Technical Report - Supporting Data and Analysis for Skagit River RFIS Appeal

**City of Burlington
City of Mount Vernon
City of Sedro-Woolley
Town of La Conner**

Skagit County, Washington

Pacific International Engineering, PLLC

Figure 10. 1921 and 2003 HWMs in the Dalles gorge (original source of data: USGS-provided spreadsheet – Concrete_03_SAM.xls)

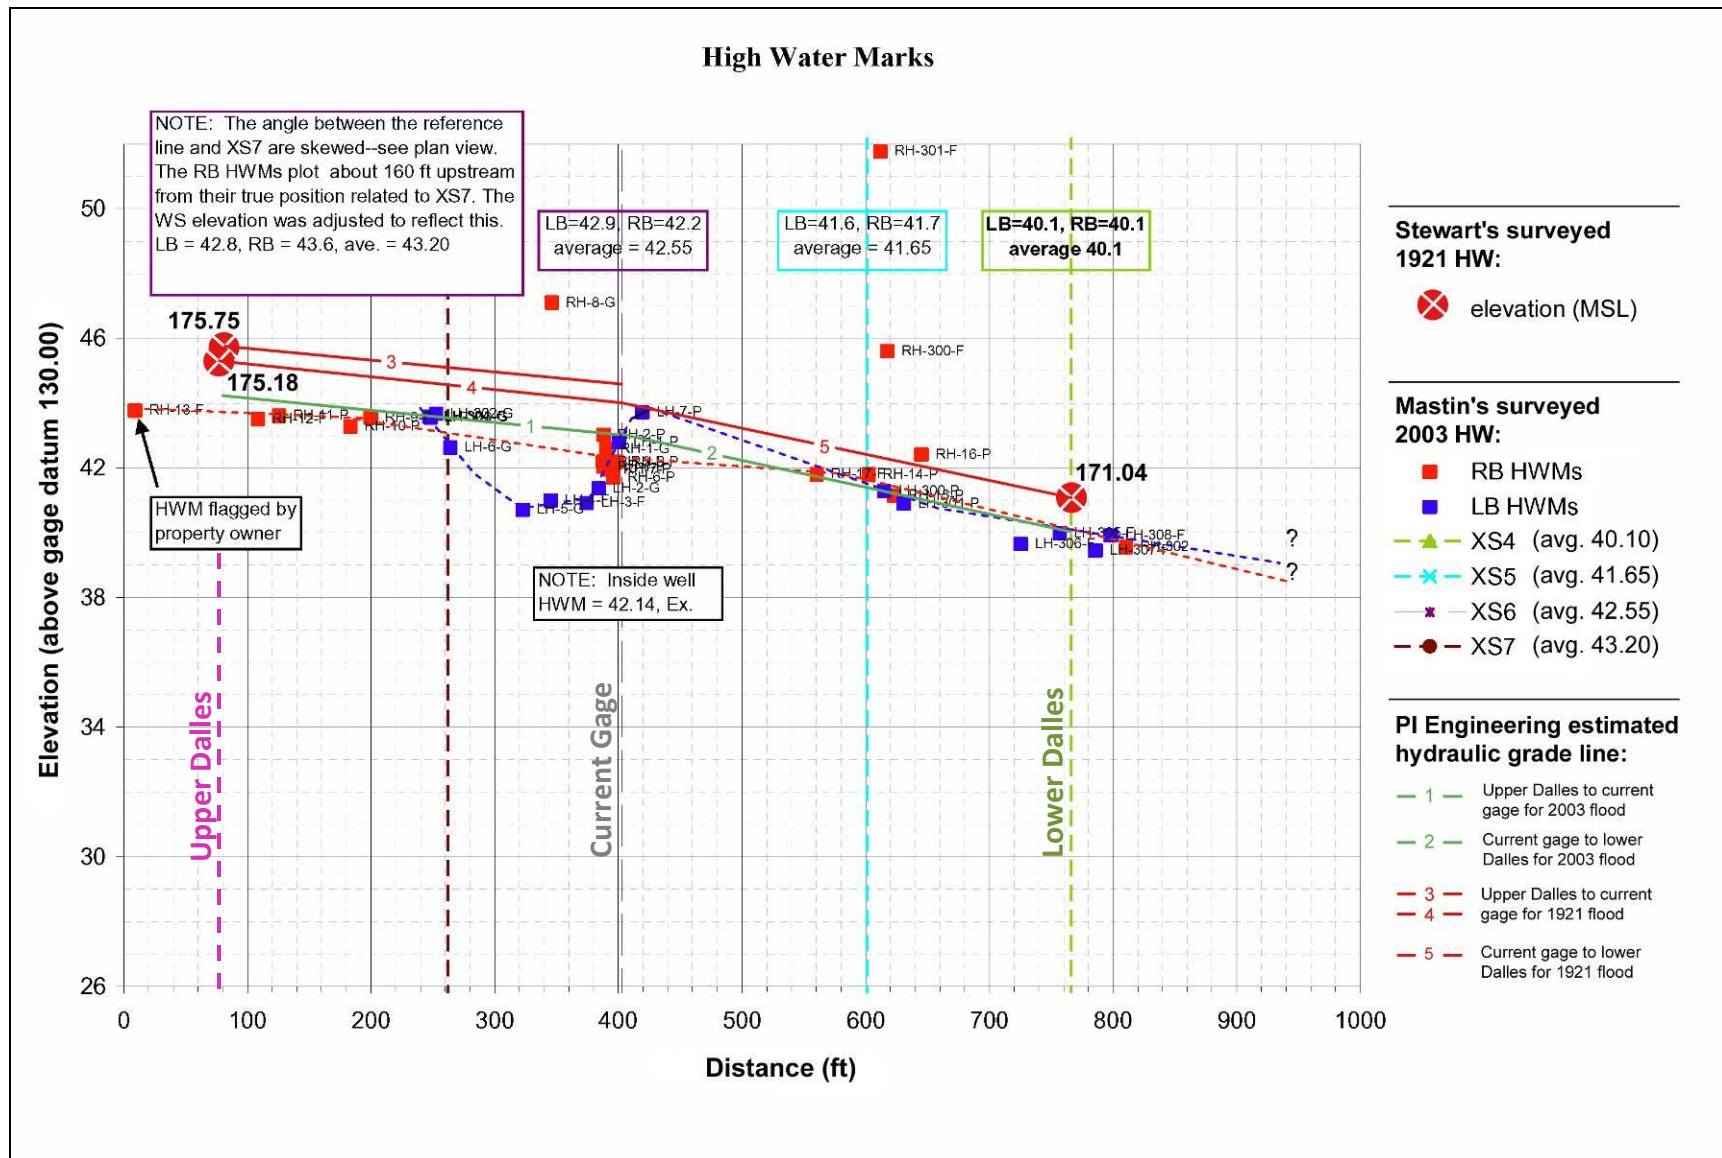
Three Stewart-surveyed 1921 HWMs (expressed in MSL) are shown in Figure 10 (an enlarged plot of Figure 9 showing only HWMs in the Dalles gorge), including 175.18 and 175.75 at his upper Dalles gage and 171.04 at his lower Dalles gage. Stewart noted that the upper Dalles is 695 ft above the lower end of the Dalles (Stewart's survey notes, p. 62). Figure 10 shows that the current gage (XS6) is located approximately 365 ft above the lower Dalles (XS4). This leads to an estimated distance of 330 ft between Stewart's upper Dalles gage and the current gage (which is more than "about 200 feet above present gage" stated incorrectly by the USGS-published Water Supply Paper 612 (USGS 1925, p. 62)).

To transfer Stewart's HWMs from the upper and lower Dalles to the current gage site, we first estimate two hydraulic grade lines between the upper Dalles and the current gage, and between the current gage and the lower Dalles, using the USGS-surveyed 2003 HWMs. These two hydraulic grade lines are plotted in Figure 10 (green lines 1 and 2). The 1921 flood hydraulic grade lines are expected to be closely parallel to the estimated 2003 flood hydraulic lines, as the channel geometry through the Dalles did not substantially change at high flood stages over the last 80 years, and the difference between the USGS-published 2003 flood peak discharge (166,000 cfs) and PI Engineering-estimated 1921 flood peak discharge (169,700 cfs, discussed later in Section 2.3.3) is not substantial. As shown in Figure 10, parallel lines (red lines 3, 4 and 5) are drawn to connect each of the three Stewart-surveyed 1921 HWMs to the current gage site. The estimated 1921 HWMs at the current gage site are thus determined by the elevation points where the hydraulic grade lines intersect the XS6 vertical line.

The amount of surging and wave wash for the 2003 flood is estimated to be 0.9 to 1.6 ft at the gage site, based on the USGS-surveyed HWMs (see Figure 10, the 0.9 to 1.6 range calculated between HWMs inside well HWM = 42.14 and outside well HWMs = 43.021 and 43.715 for surveyed points RH-2 LH-7, respectively). Using 0.9 and 1.6 ft for the estimated amount of surging for the 1921 flood at the current gage site, the 1921 flood stage inside the gage well would be 173.3 and 172.6, respectively (or 43.3 and 42.6 above the current gage datum of 130.00).

Figure 17. USGS published estimate of 1932 unregulated flood peak discharge at Concrete (source of data: Figure 4 – Hydrographs showing effect of dams on flood peak, USGS 1961)

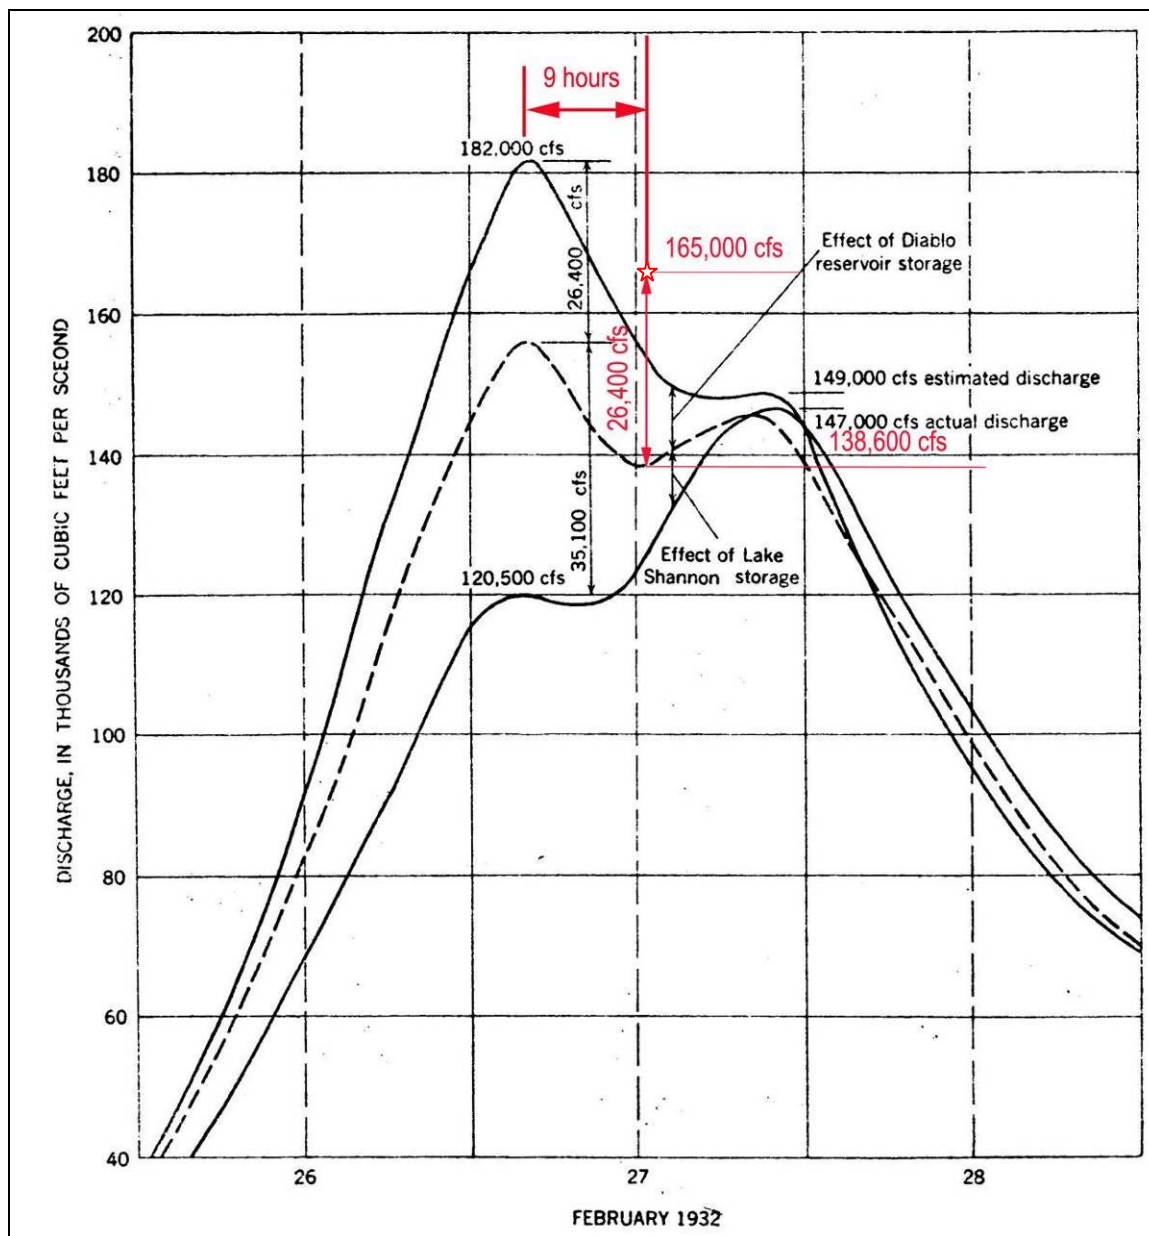
The RFIS flood frequency analysis uses an unregulated peak discharge for the 1932 flood, based on an estimate made by USGS and published in the Water Supply Paper 1527 (USGS 1961). Figure 17 is the figure from Water Supply Paper 1527 (USGS, 1961, Figure 4) showing the USGS' estimate. The USGS estimated unregulated peak discharge is 182,000 cfs, which is used by the Corps of Engineers in the RFIS hydrology analysis (USACE 2008). We believe this estimate is incorrect, as discussed below.

As shown in Figure 17, USGS estimated the effects of Diablo and Lake Shannon storage to be 26,400 and 35,100 cfs, respectively, on reduction of the peak flows occurring at the same time, approximately 4 to 5 AM on February 27, 1932. Adding these to the regulated 120,500 cfs observed at the Skagit River gage near Concrete at that time, results in the USGS estimated unregulated peak discharge of 182,000 cfs. The regulated peak flow actually recorded and published by the USGS at the gage is 147,000 cfs at about 10 PM on February 27, 1932.

The USGS unregulated peak of 26,400 cfs from Diablo reservoir as shown in Figure 17, was delayed by 9 hours to arrive at the gage near Concrete approximately at 1 PM on February 27, 1932. Adding this flow to 138,600 cfs scaled from the figure, which is the sum of the USGS unregulated flow from Lake Shannon and the flow observed at the gage near Concrete at 1 PM on February 27, 1932, results in the unregulated peak flow estimate of 165,000 cfs. Lack of details and data used in the USGS unregulated flow estimate prevents us from performing a complete hydrograph unregulation.

It is our opinion that our revised unregulated peak discharge of 165,000 cfs is more accurate than the USGS estimated 182,000 cfs for the 1932 flood.

Figure 22. Right Bank Levees on Mainstem and North Fork Skagit River Removed While All Other Levees Remain Intact (original source: Figure 9, COE 2009)

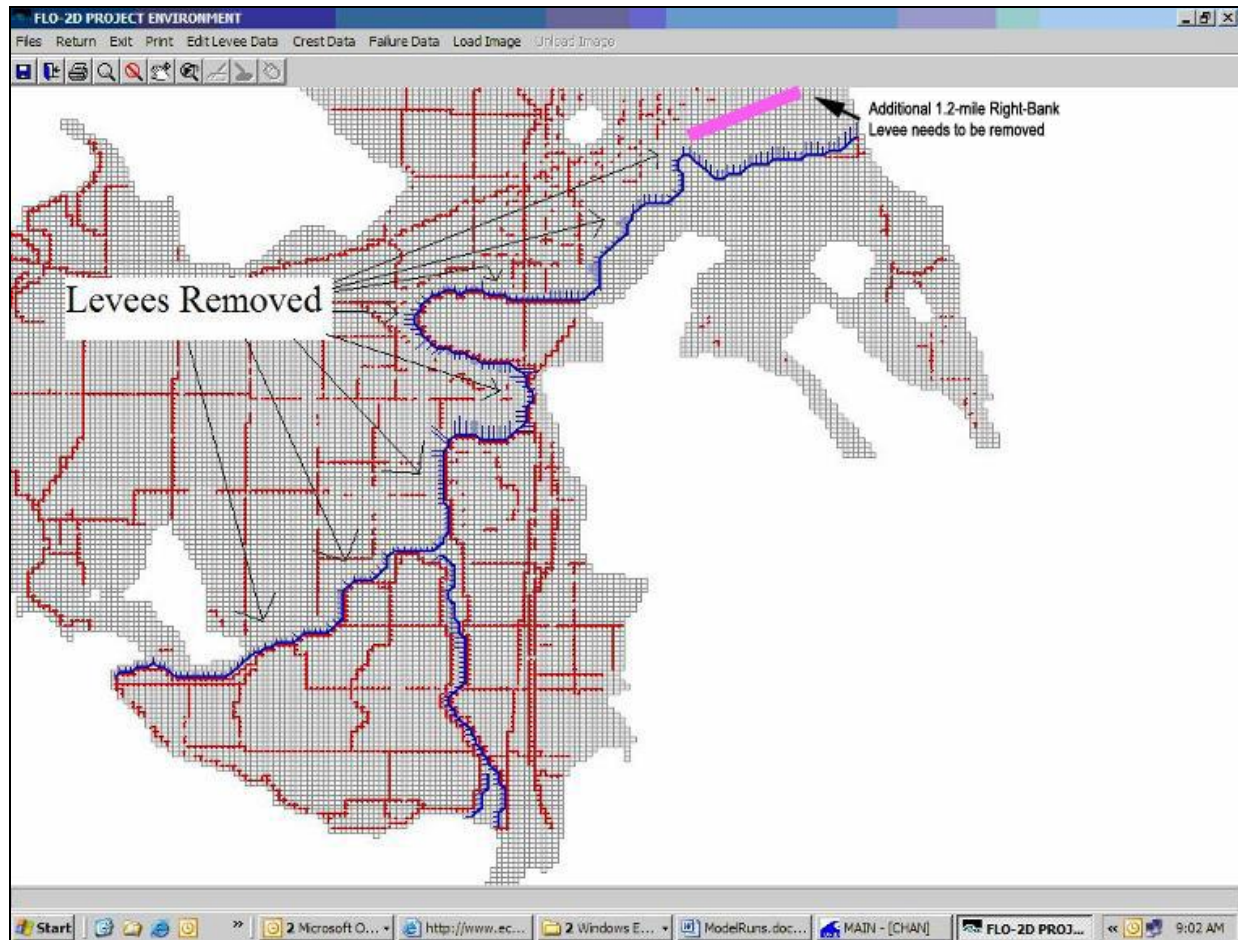
PI Engineering reviewed the model runs for these seven levee removal scenarios, and found that the levee methodology was inconsistently applied to the scenario shown in Figure 22 - Right Bank Levees on Mainstem and North Fork Skagit River Removed While All Other Levees Remain Intact. For this scenario, the removed right-bank levee starts upstream approximately at RM 21 in the current model. It is our opinion that an additional 1.2-mile levee (RM 21 – 22.2) upstream also needs to be removed, as annotated in the figure.

- (1) Extending the right-bank uncertified levee upstream for 1.2 miles along the SR-20 roadway and BNSF railway fill corridor including the 20-ft high dam at the Gages Slough inlet in the Sterling area as shown in Figure 22.

Figure 23. Depiction of the Floodplain Scenario Location of Implementation (original source: Figure 11, COE 2009)

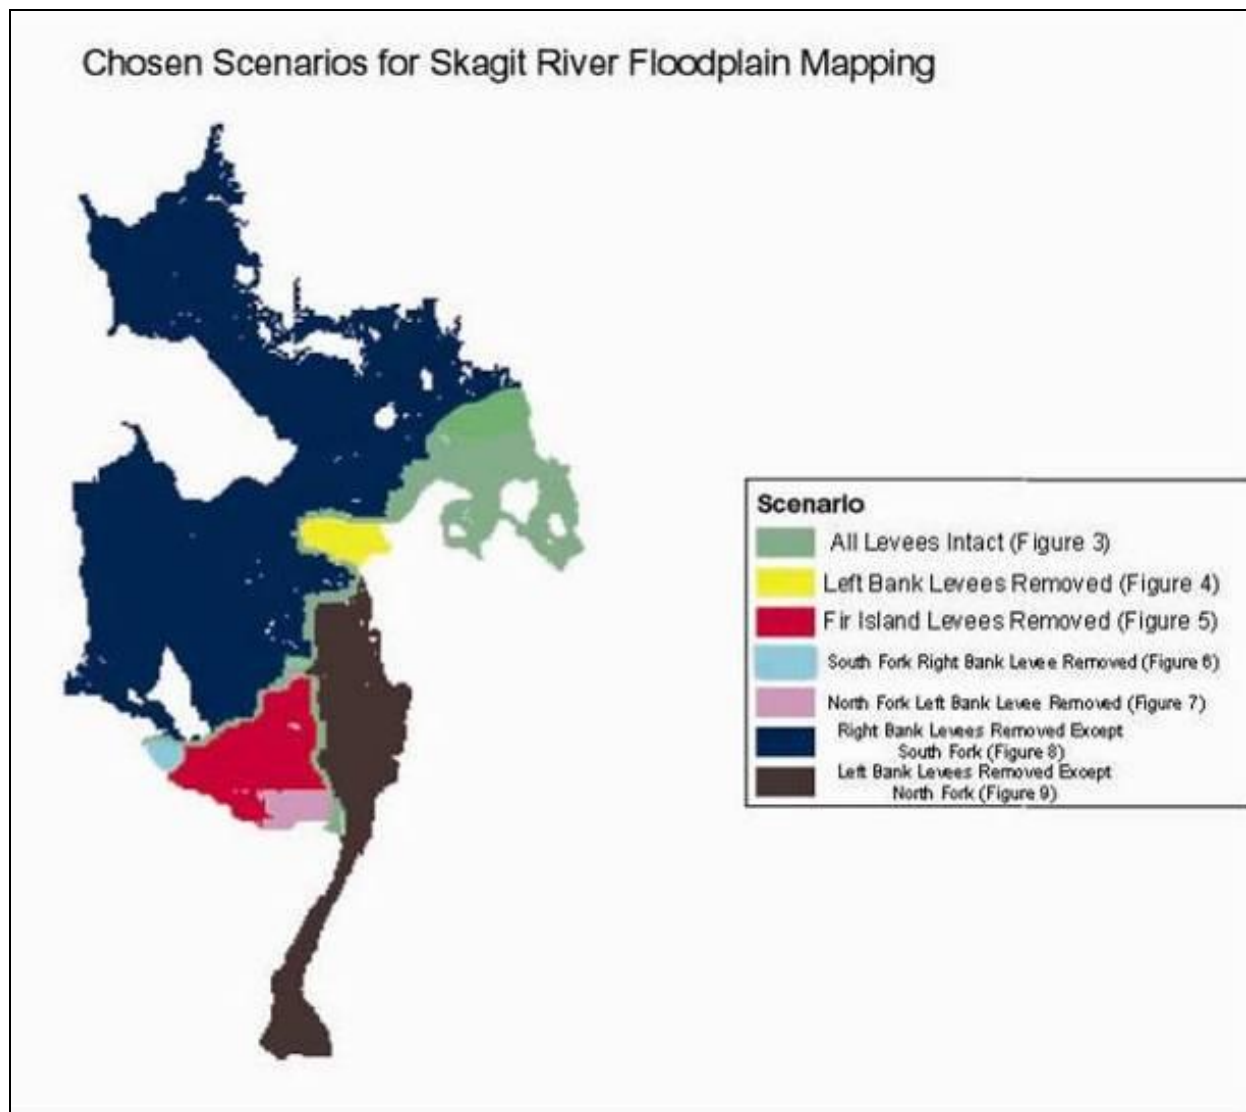
The flood mapping and modeling for the preliminary DFIRM and RFIS are not consistent in treating this fill reach. In mapping the floodplain, this reach was considered as a part of the right bank uncertified levee, as shown in Figure 23 (which is the Figure 11 of the COE hydraulics summary report, COE 2009). But when modeling the base flood elevations for the right bank floodplain, it was not included as a part of the right bank uncertified levee in the model. To correct this inconsistency, the right-bank levee removal scenario needs to extend upstream to include the removal of this 1.2-mile fill as an uncertified levee.

Figure 24. Comparison of COE Original and PIE Revised FLO-2D Model Levee Alignments

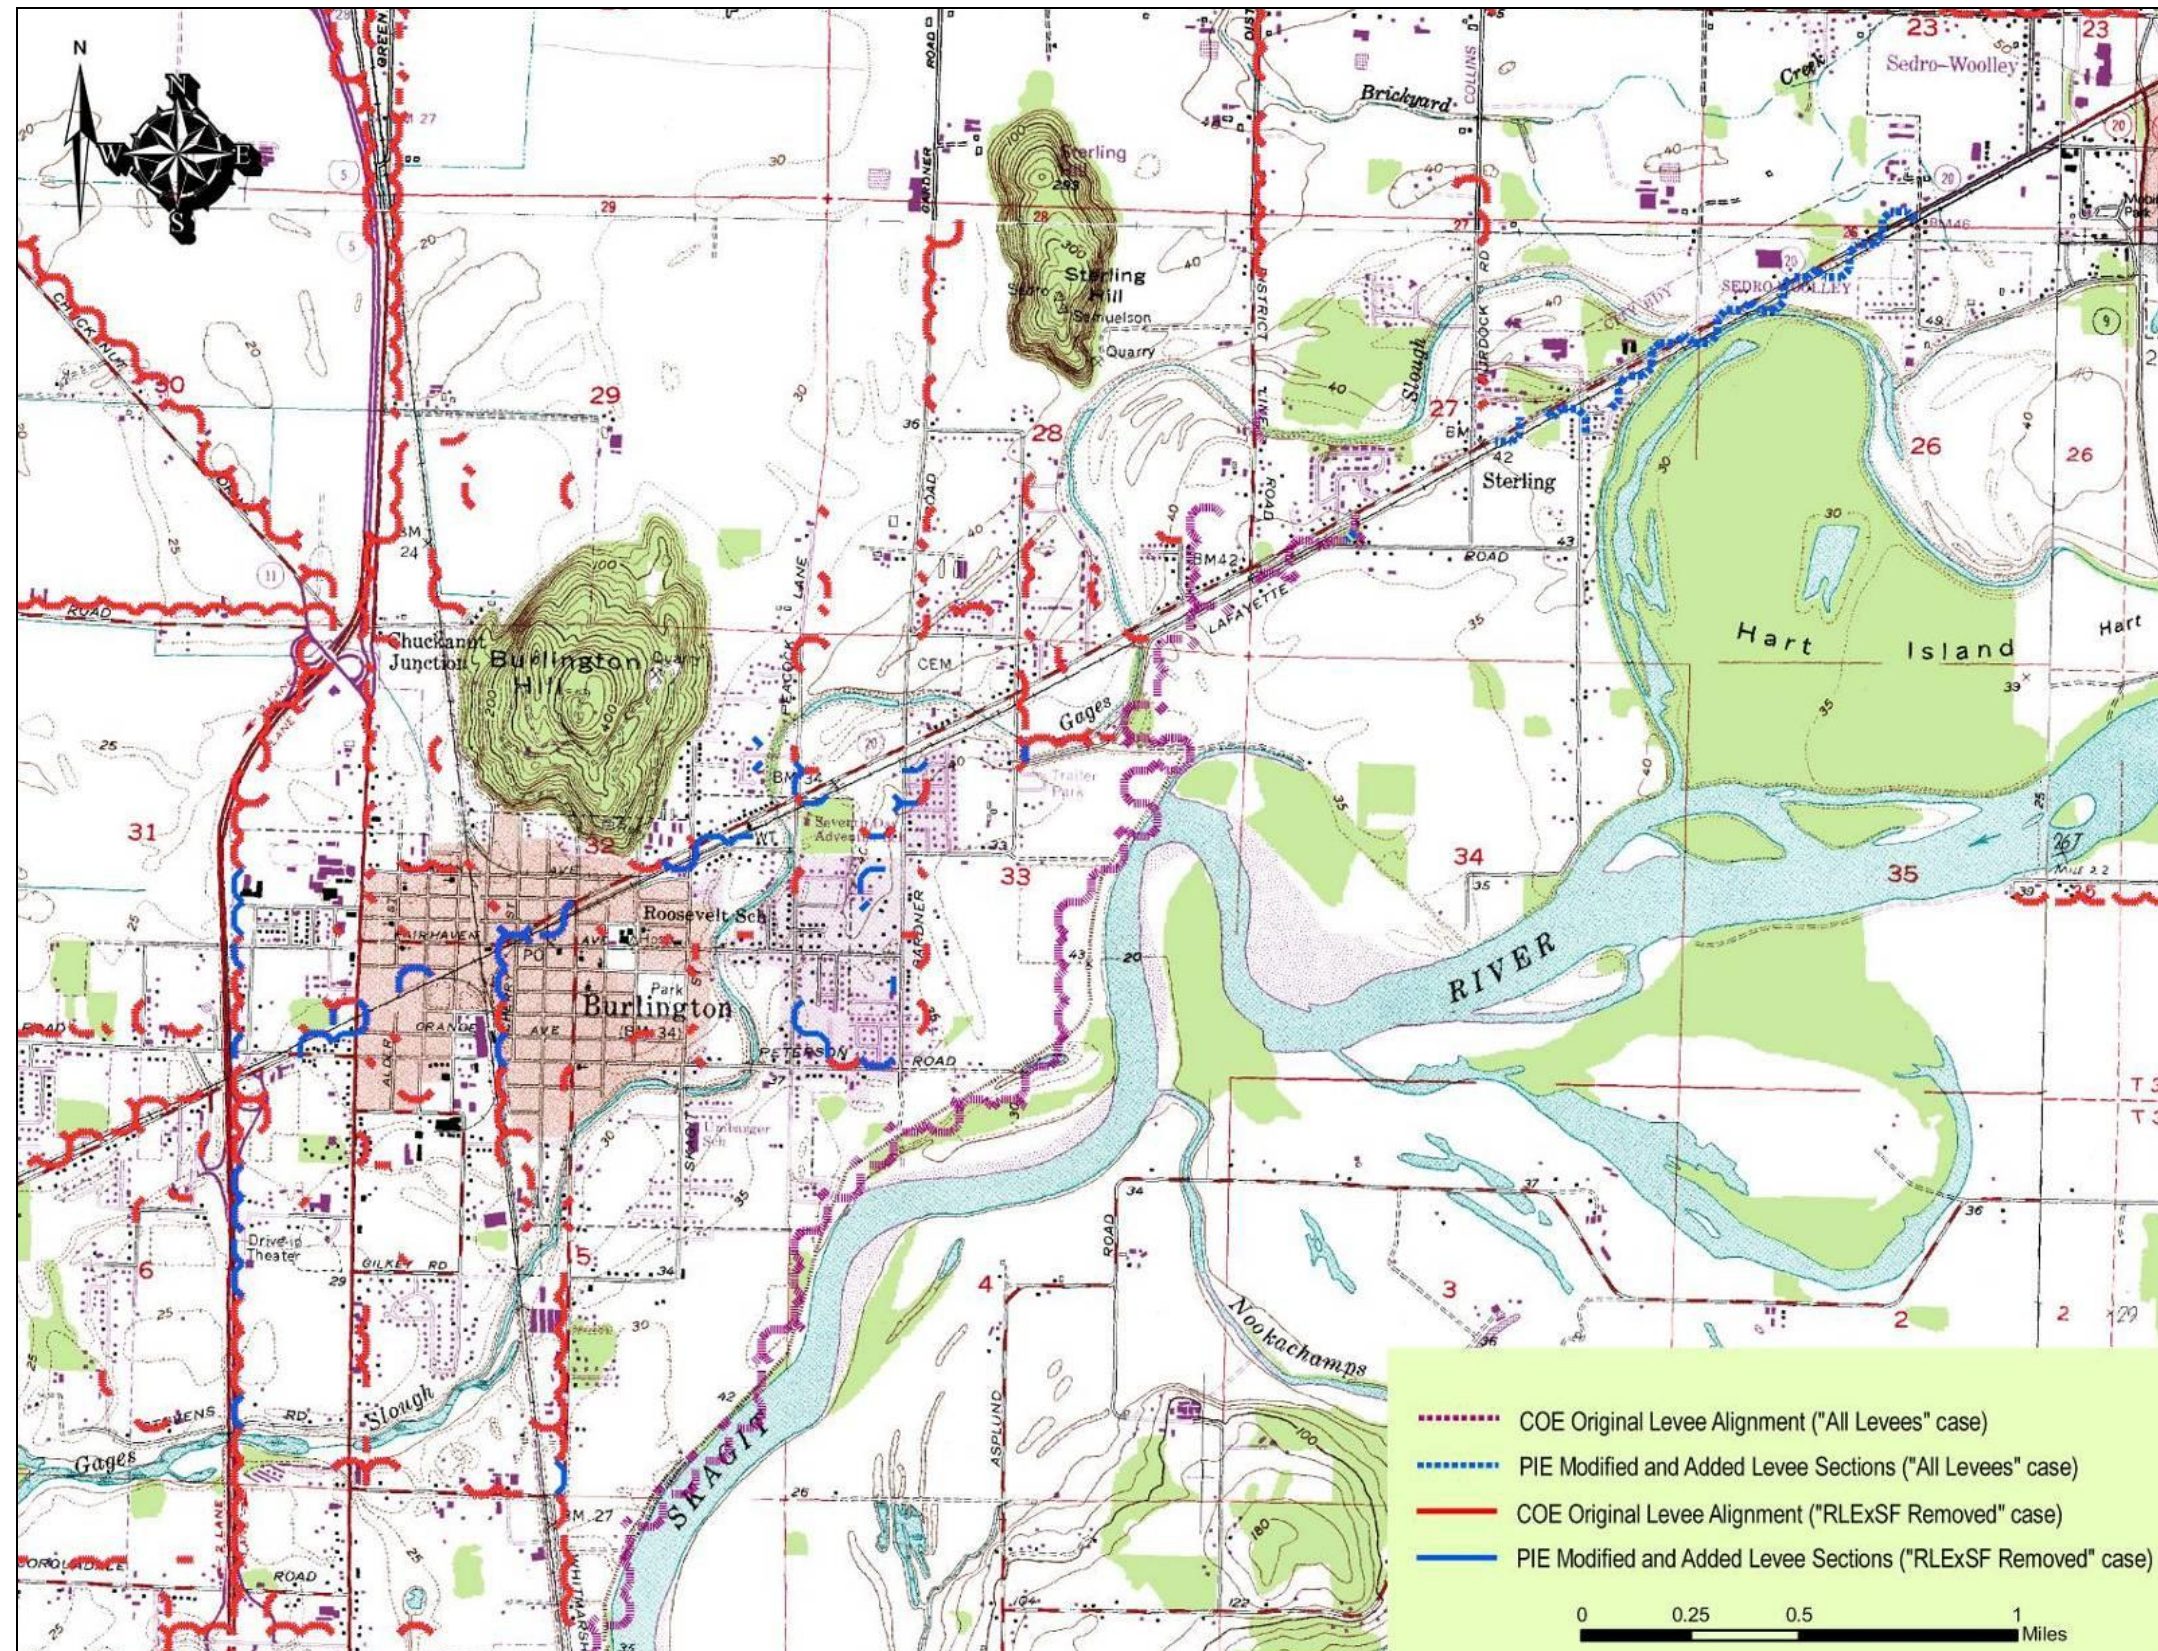
Figure 24 shows the FLO-2D model levee alignments revised by PI Engineering to include the extension of this 1.2-mile right-bank uncertified levee, in comparison with the model levee alignments originally developed by the COE. The figure also shows other PI Engineering revised levee segments representing

- (2) Adding or deleting other segmental levees representing high ground or road fill in the City of Burlington and Gages Slough floodplain area as shown in Figure 24.
